## ADDENDUM NO. 1

From: ADDENDUM NO. 1 DCR Contract # P25-3582-C1A

### Notice of Modifications of PS&E Package

**WALTHAM**  
**MCR T WALTHAM LINDEN STREET BRIDGE**

**SPLIT RAIL FENCE DETAILS**  
NOT TO SCALE

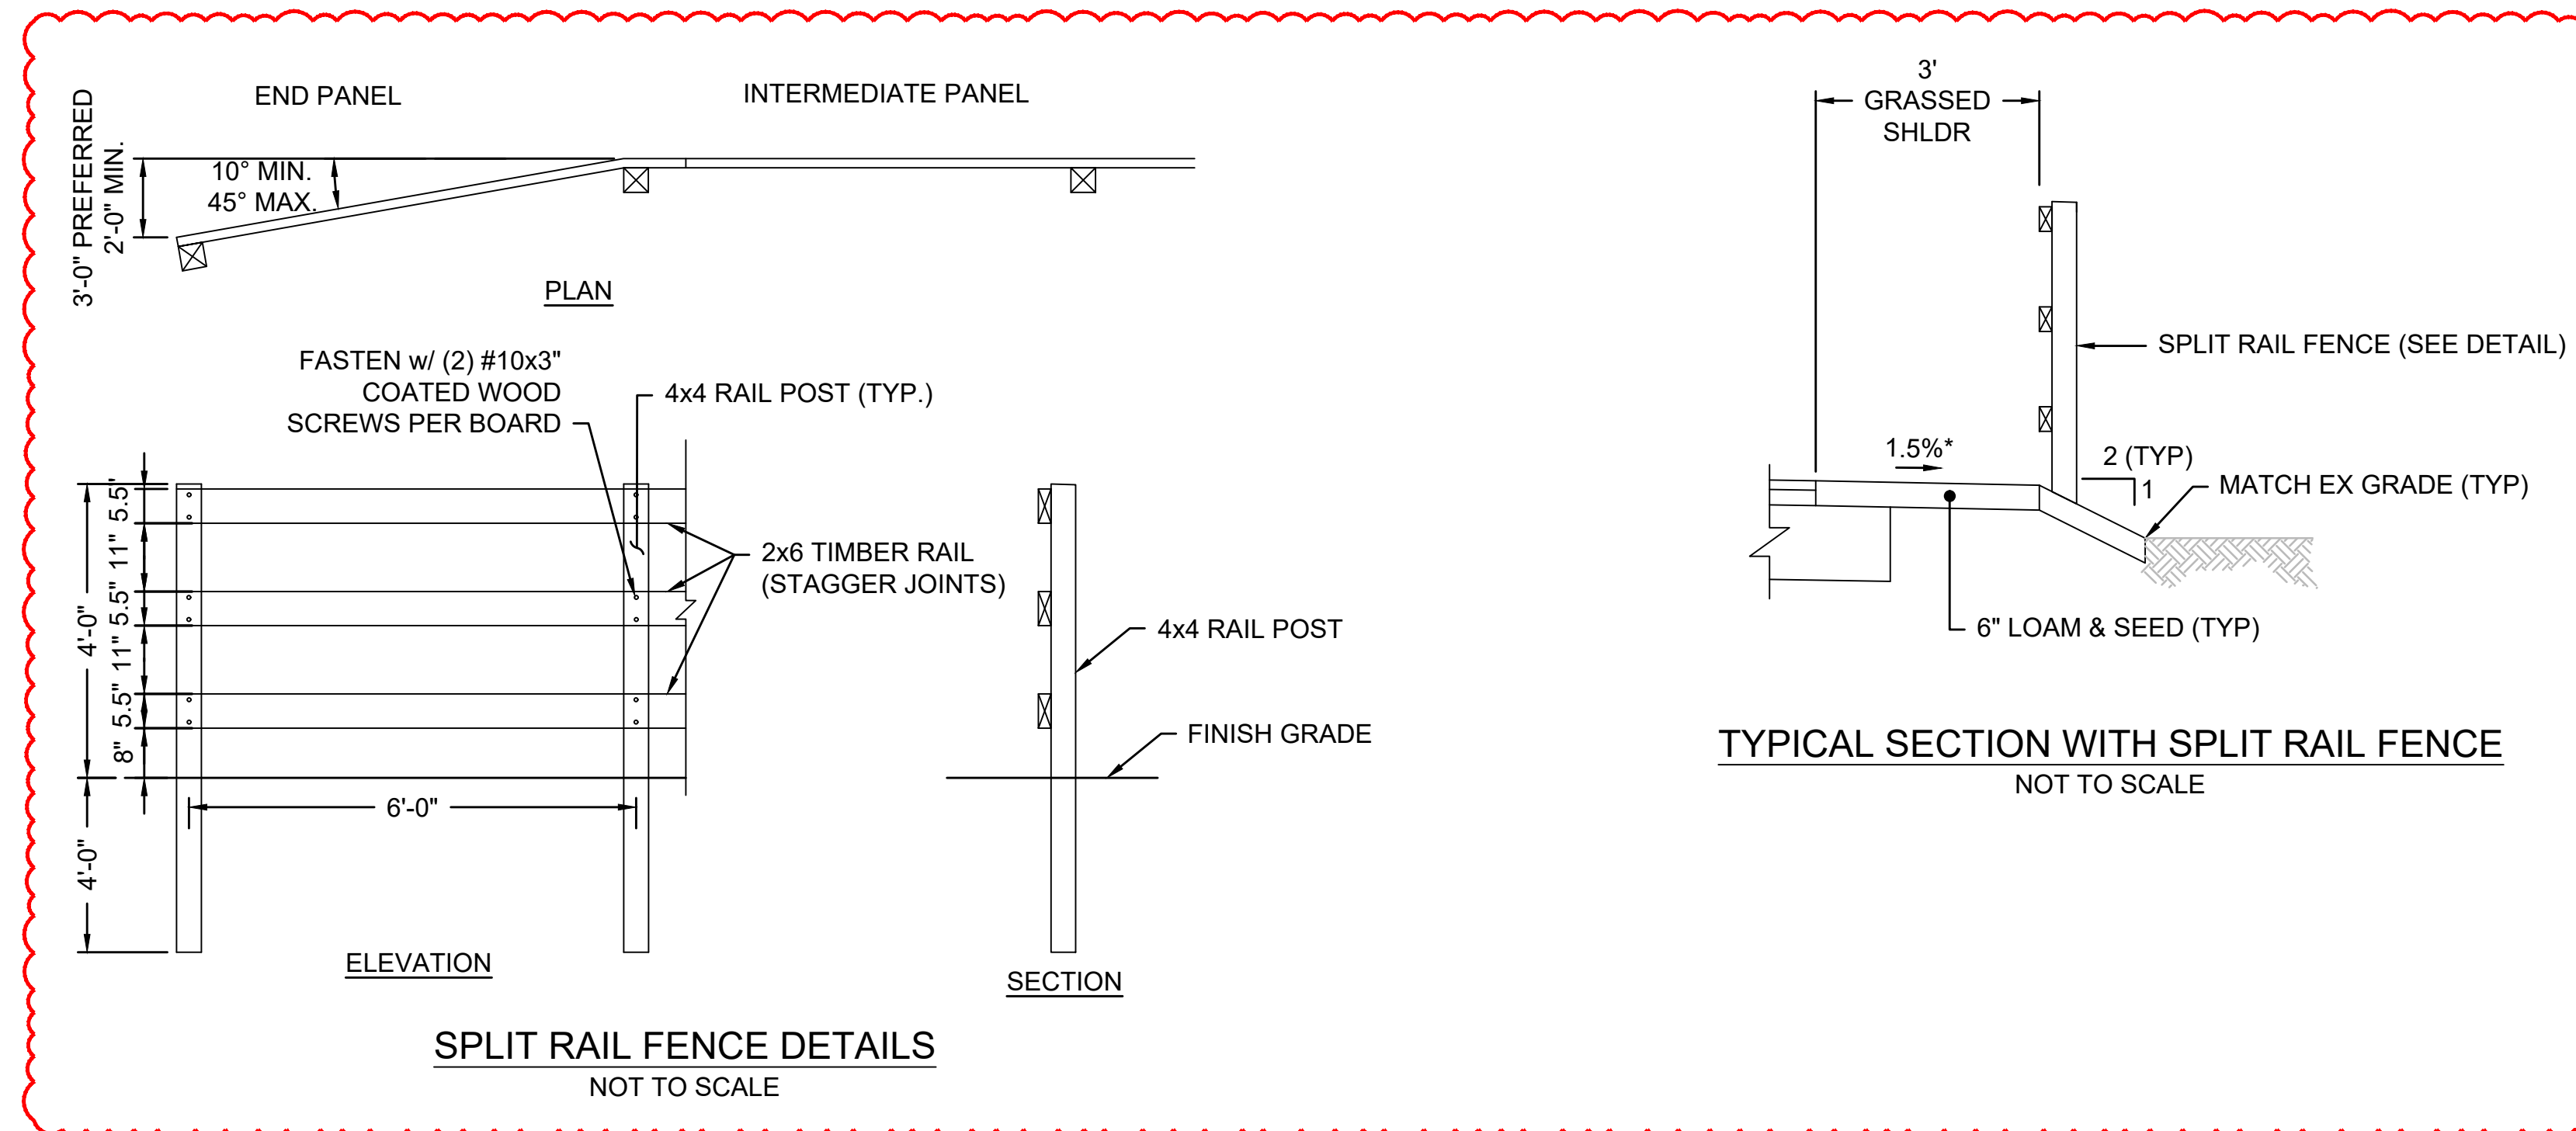
1. Plan Sheet 4 – The Split Rail Fence detail has been revised.
2. Plan Sheet 5 – An existing tree has been added to the plan east of the bridge.
3. Plan Sheet 9 – Structural Steel Notes 3 and 8 have been revised. Shielding Note 3 has been added. The bronze plaque dimensions have been revised.
4. Plan Sheet 11 – The gap dimension in the C.I.P Concrete Timber Deck Support Detail has been revised.
5. Plan Sheet 14 – The attachment detail callout in Rail Detail has been shifted.
6. Plan Sheet 15 – The split-rail fence has been modified to match the revised detail on Sheet 4. Some text has been adjusted for clarity but not otherwise modified.

At the Linden Street Bridge, the proposed split rail fence is called out to meet the existing fence. However, the “Split Rail Fence Details” on plan sheet #4 do not match the detail of the existing fencing along the trail, as the existing rail does not have the 2x8 top rail @ 30 degrees. Please advise.

The detail has been modified by addendum to remove the top and back rails.

**CONSTRUCTION PLAN - 1**

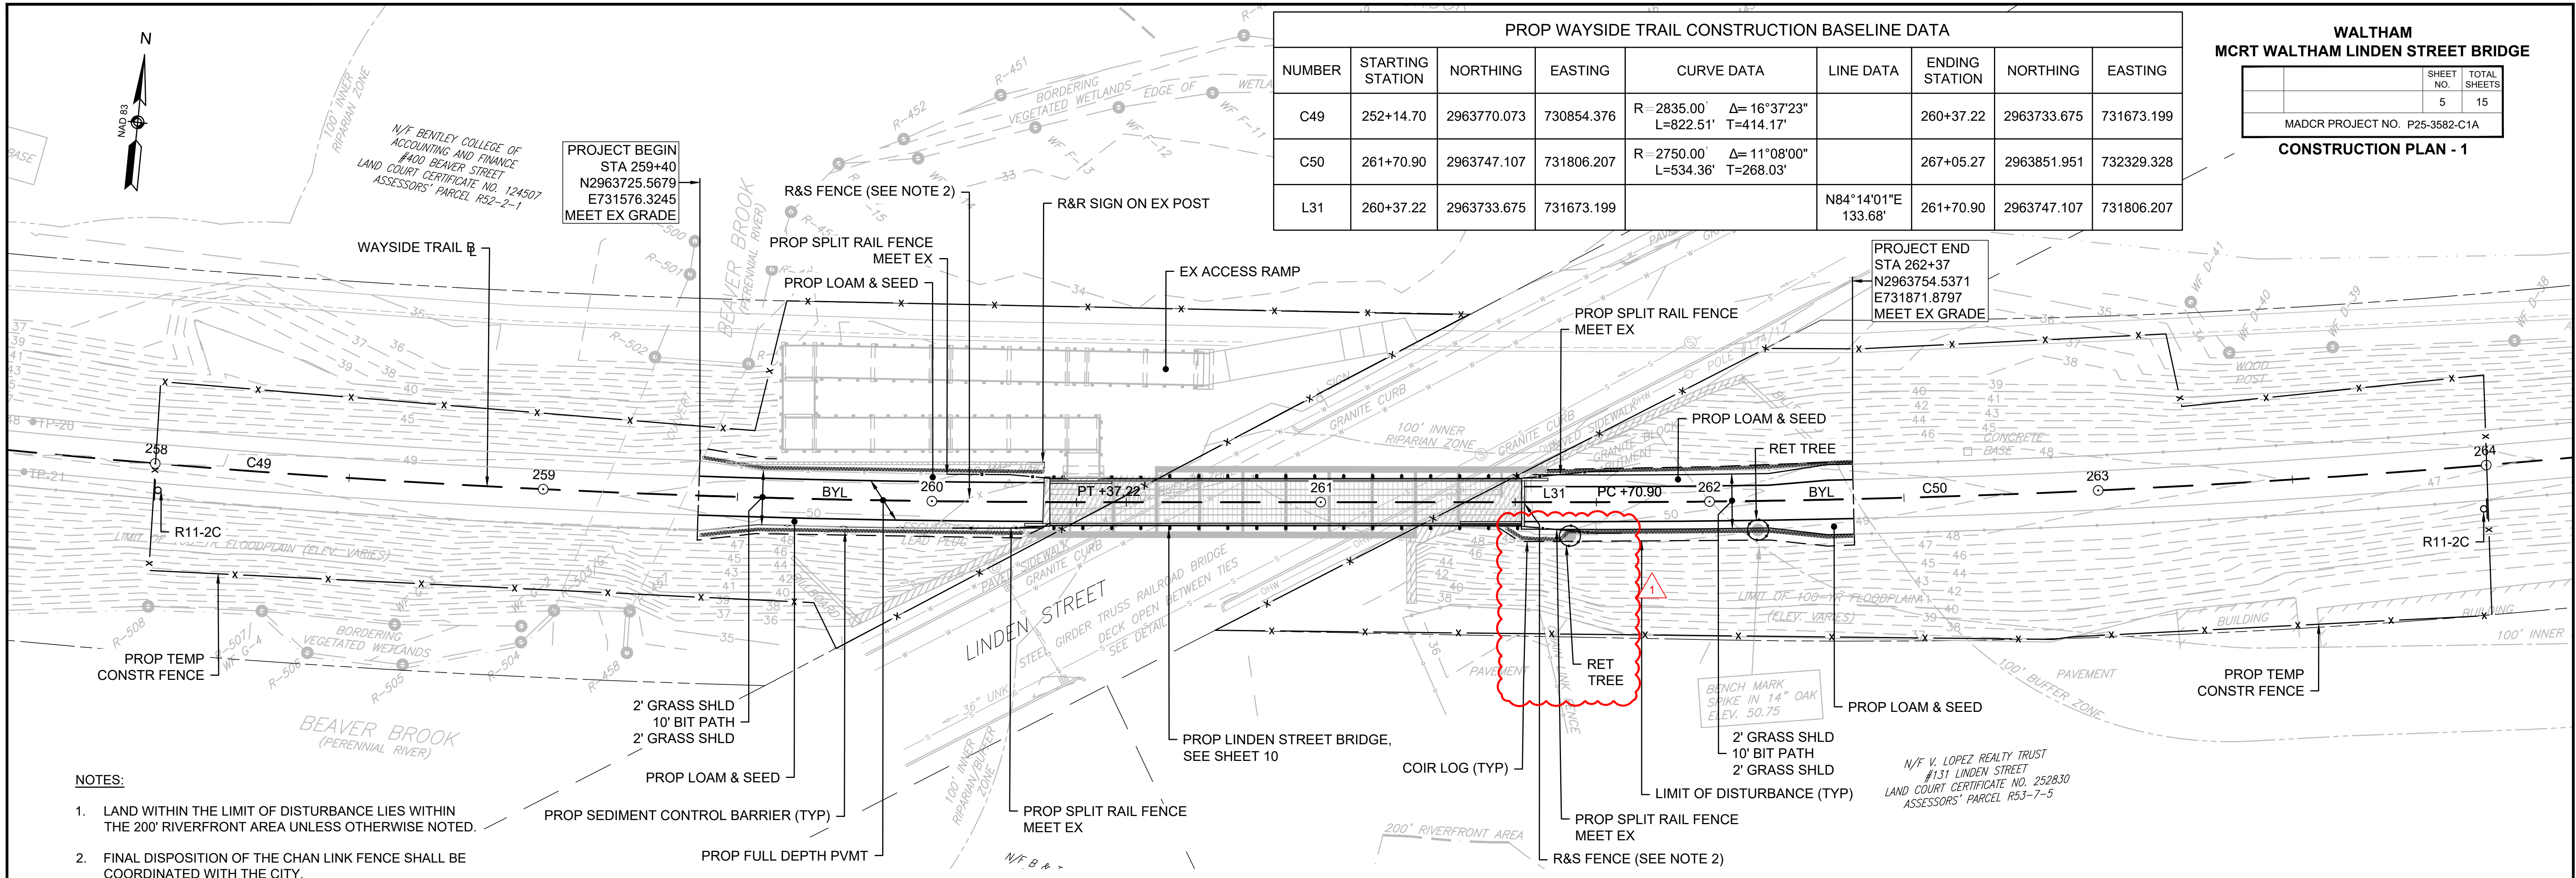
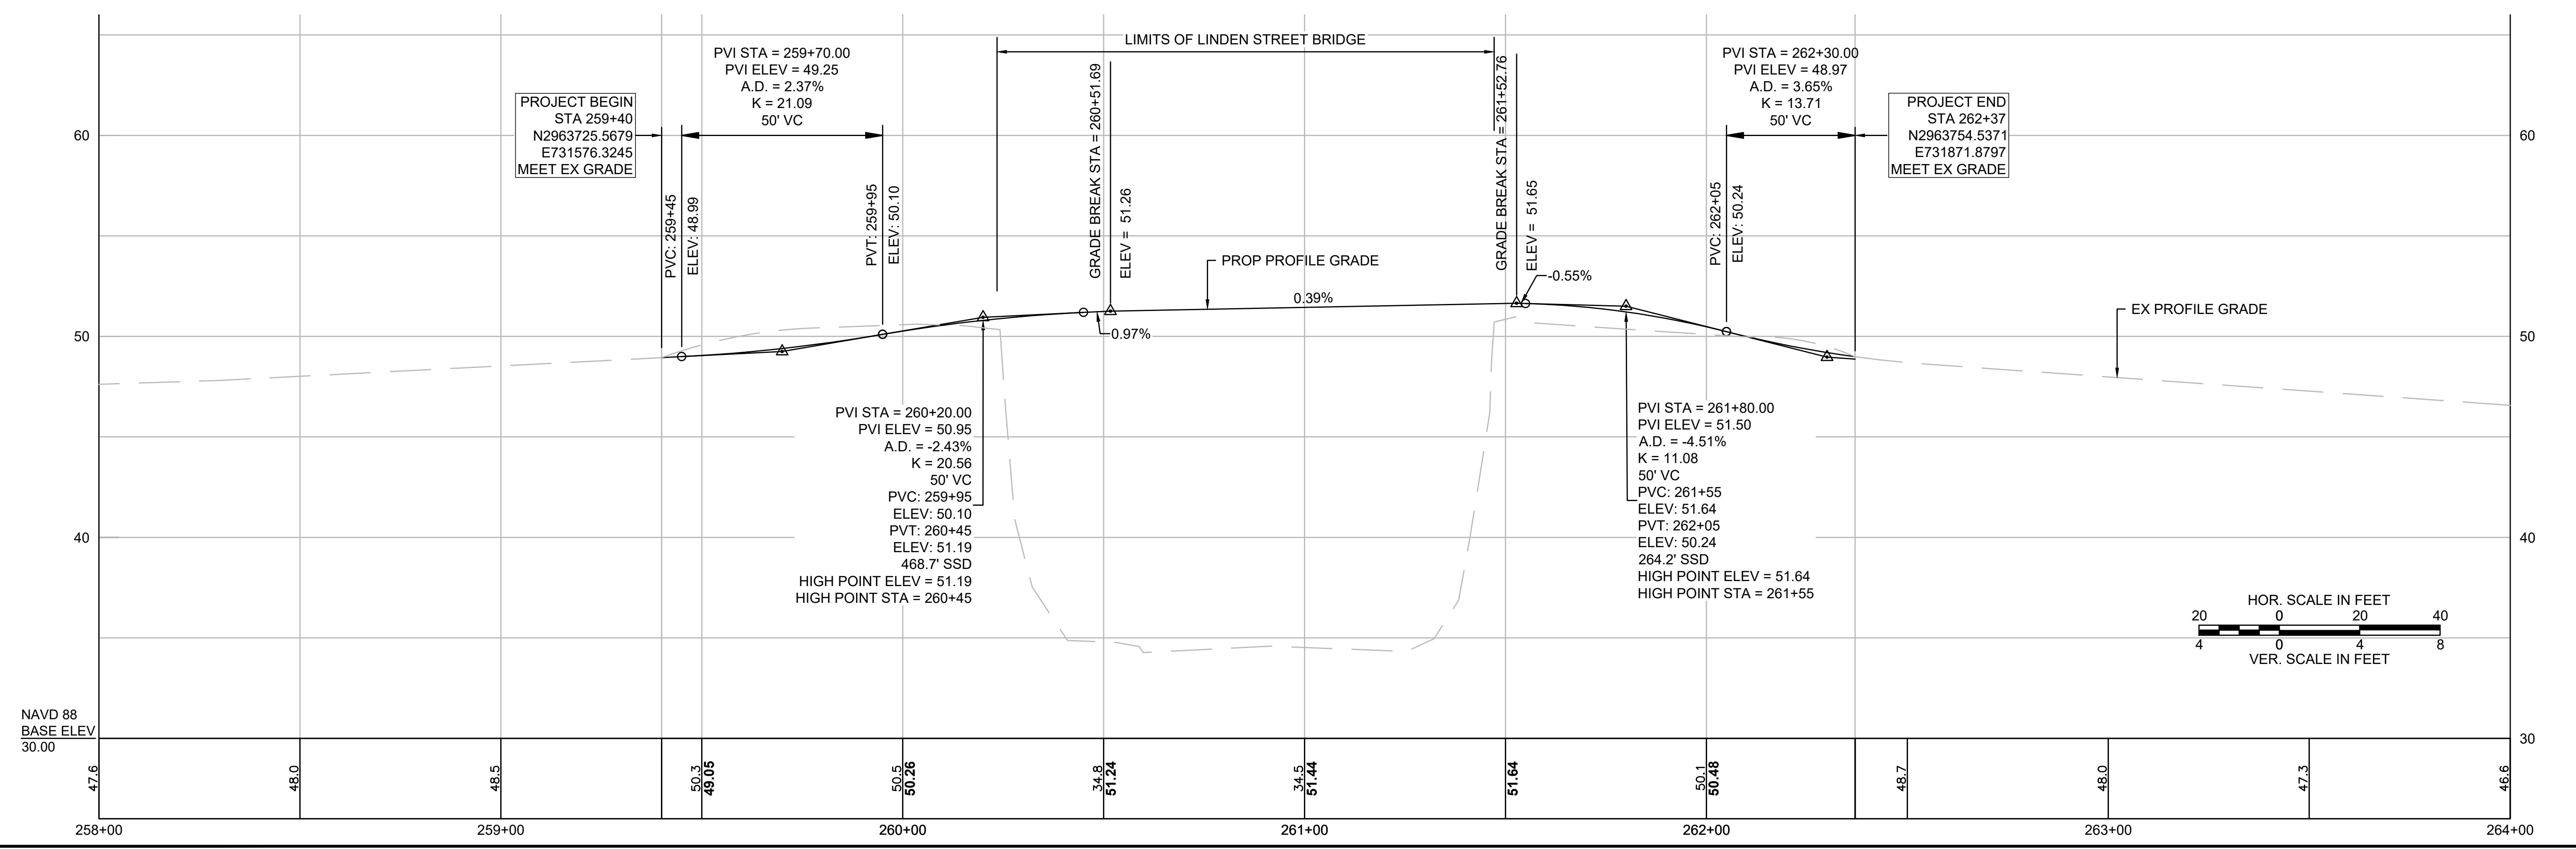
Drawing sheet 5 shows a new broken yellow line on the new bridge paving. Is this line to be paint or thermoplastic? What pay item will be used for this marking?

Plan sheet #5 calls for broken yellow line "BYL" pavement markings along the trail and across the bridge at Linden Street. There is no pay item for yellow pavement markings. Please add a bid item for yellow paint.

The line will be thermoplastic. A pay item has been added by addendum.

A pay item has been added by addendum.
